Access Compliance Report

Public Rights-of-Way

(Curb Ramps)

Intersection ID: 28303	Main Street: CASTLEBAY_DR	Cross Street: TAMARACK_DR	Location: NW
ADA ID: F5C57258537C	Ramp Type: Perp	Initial Pass/Fail: Fail	Overall Compliance: No
Severity Score: 12.5			
Codes/Mitigation Info/Possible Solution		Field Measurements/Component Compliance

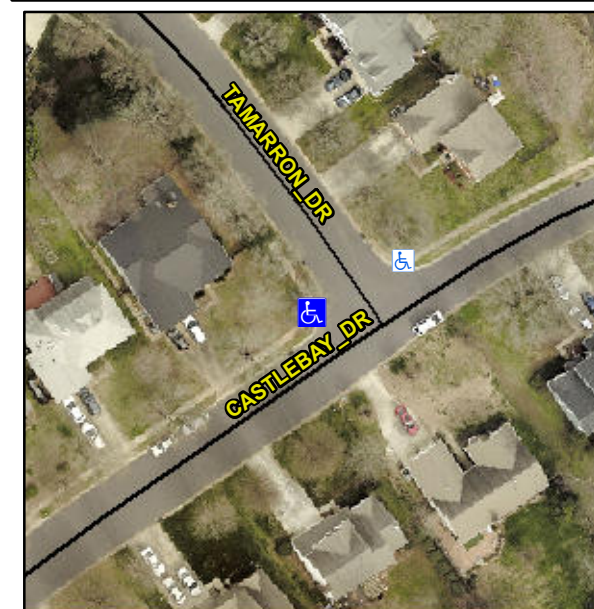
Not Found, R304.2.2

Compliance	Description	Data	Compliance	Description	Data
N/A	Ramp Length (in)	46.0	No	Ramp Slope (%)	9.1
Yes	Ramp Width (in)	73.0	Yes	Ramp XSlope (%)	0.7
N/A	Flare Type LT	N/A	N/A	Flare Type RT	N/A
N/A	Flare Slope LT (%)	N/A	N/A	Flare Slope RT (%)	N/A
N/A	Flare Traversable LT?	N/A	N/A	Flare Traversable RT?	N/A
N/A	Landing Length (in)	N/A	N/A	DWS Provided?	N/A
N/A	Landing Width (in)	N/A	N/A	DWS Contrast?	N/A
N/A	Landing Slope (%)	N/A	N/A	DWS Length (in)	N/A
N/A	Landing X Slope (%)	N/A	N/A	DWS Full Width?	N/A
N/A	Landing Curb? (Y/N)	N/A	N/A	DWS Offset (in)	N/A
N/A	Shared Landing?	N/A			
N/A	Gutter Ponding?	N/A	N/A	Gutter Slope (%)	N/A
N/A	Gutter Lip Ht (in)	N/A	N/A	Gutter X Slope (%)	N/A
N/A	Painted X Walk1?	No	N/A	Painted X Walk2?	N/A
	X Walk 1 Direction	To SE		X Walk 2 Direction	N/A
N/A	X Walk 1 Width (in)	N/A	N/A	X Walk 2 Width (in)	N/A
	X Walk 1 Slope (%)	1.5		X Walk 2 Slope (%)	N/A
	X Walk 1 X Slope (%)	0.1		X Walk 2 X Slope (%)	N/A

Remove & Replace Entire Ramp.
